SURVEYOR'S OFFICE
Hamilton County

RE: Freemont Randall Drain

Attached is a petition from Robert C. Langston, along with plans for the relocation of the Freemont Randall Drain. I have reviewed the plan and believe the plan to be acceptable as it will improve the operation of the existing tile.

OFFSITE STORM & SANITARY SEWER

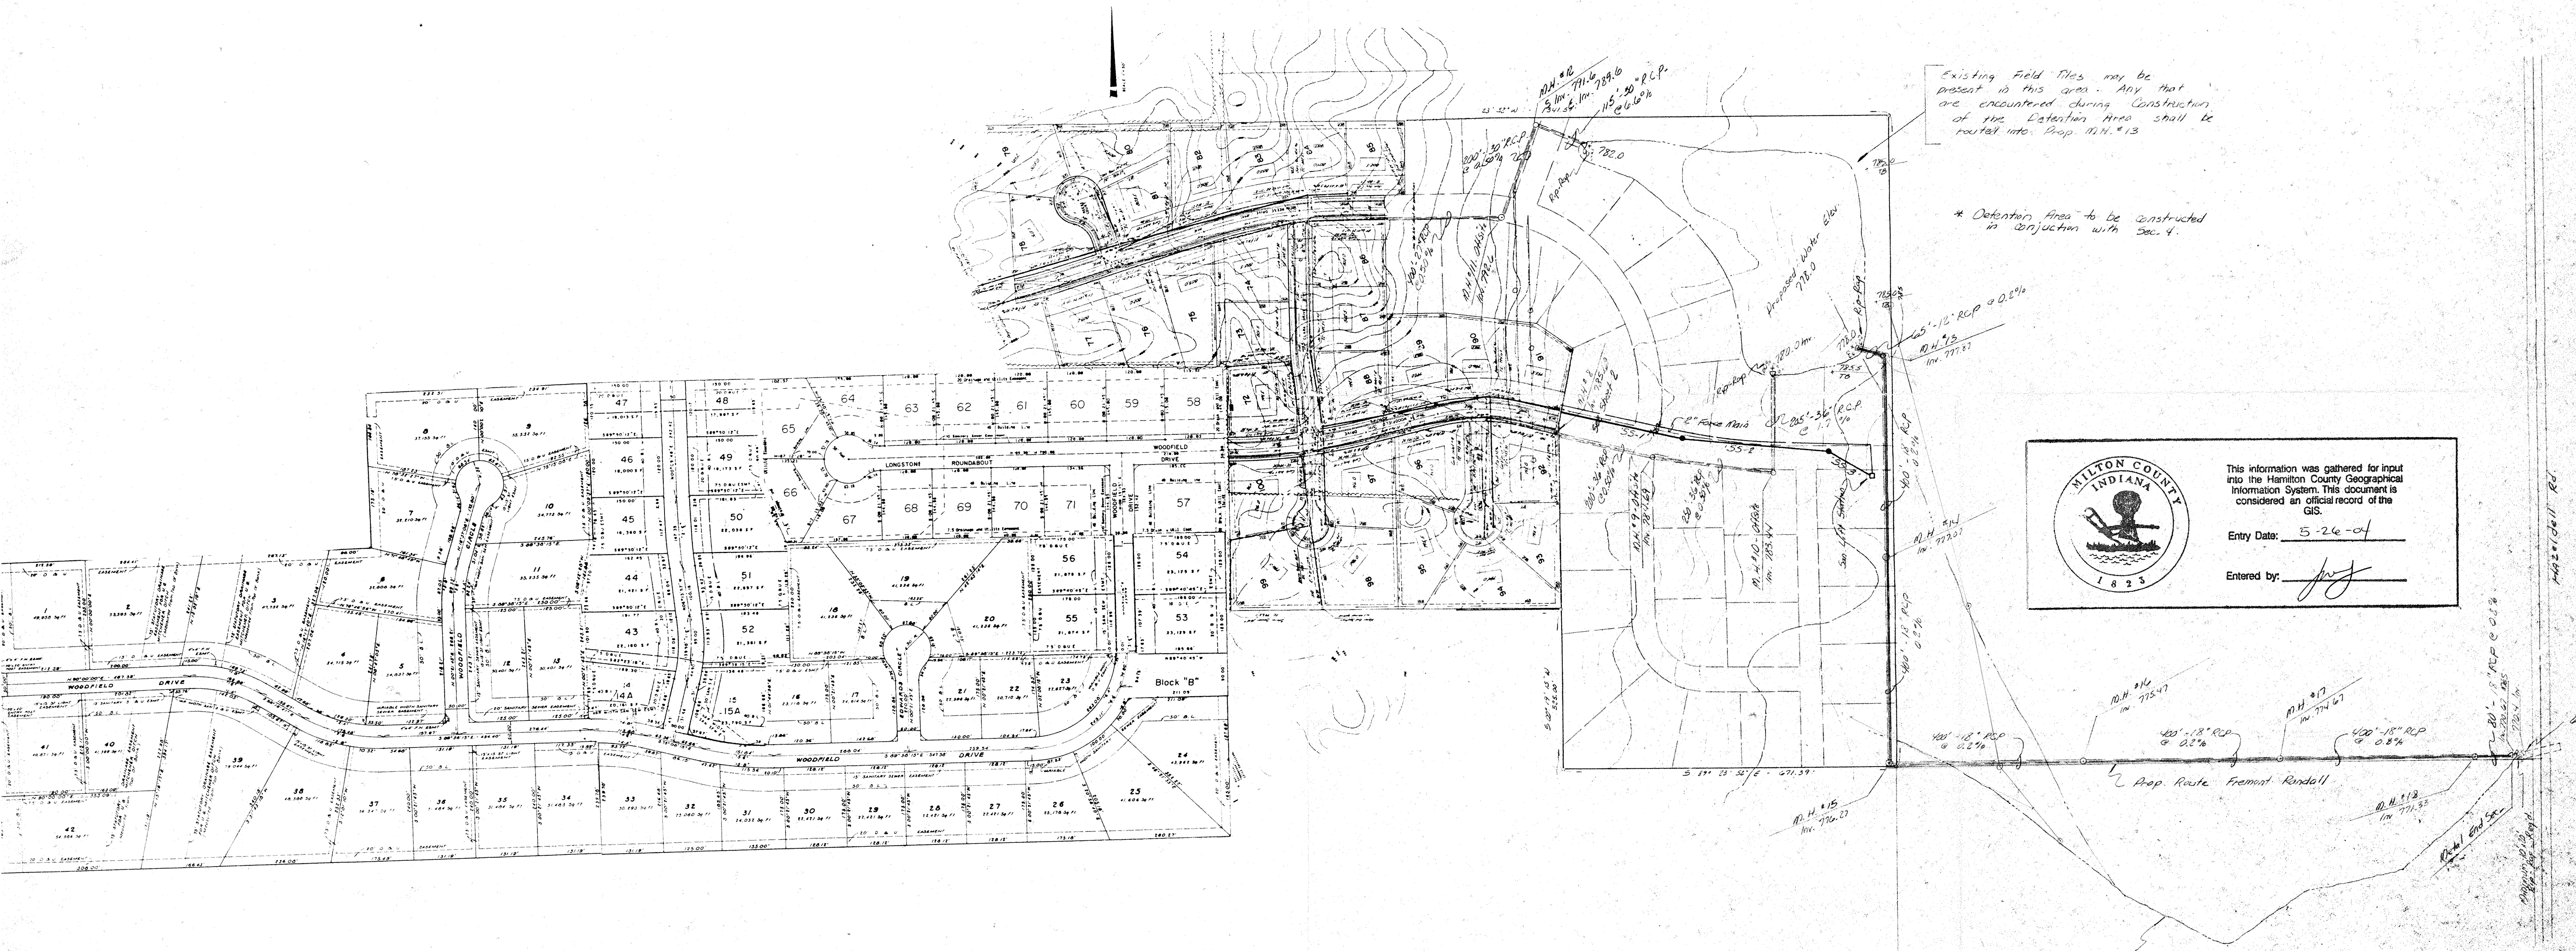
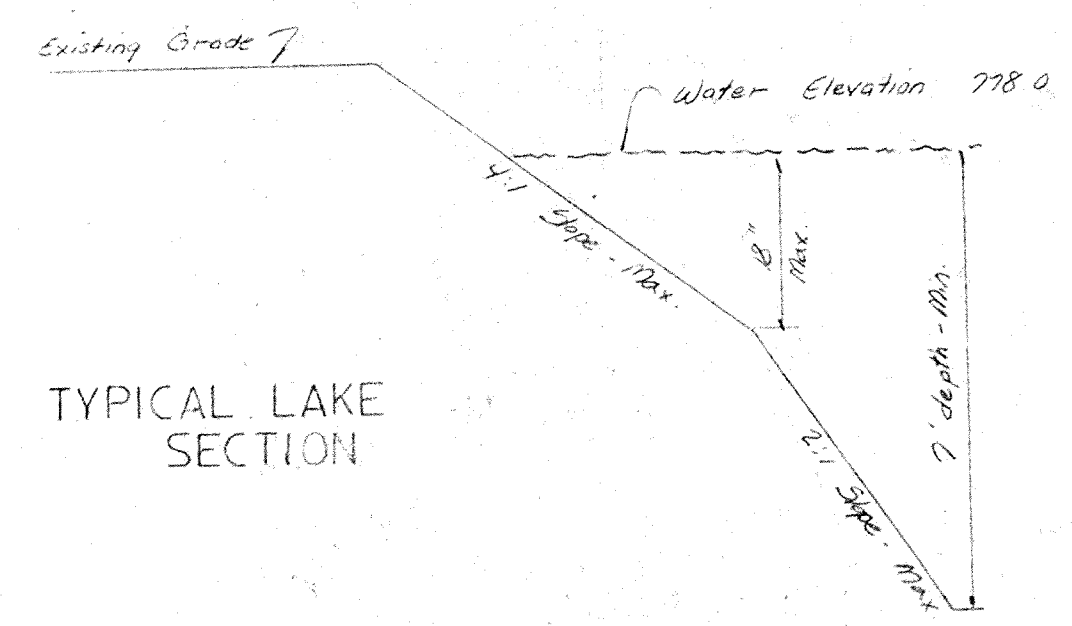
The relocation will involve Arm #1 and the Main Drain. STATION 0 to STATION 2+00 of Arm #1 will be abandoned along with STATION 0 to STATION 9+65 of the main ditch. The remainder of the original drain will remain as regulated drain.

To be added will be 2000 feet of 18" RCP and 65 feet of 12" RCP. The new portion of the drain shall begin as an outlet of the retention area in Woodfield and run South to the SouthEast corner of Woodfield, then East to the West side of Hazeldale Road. The developer shall construct this system at his expense.
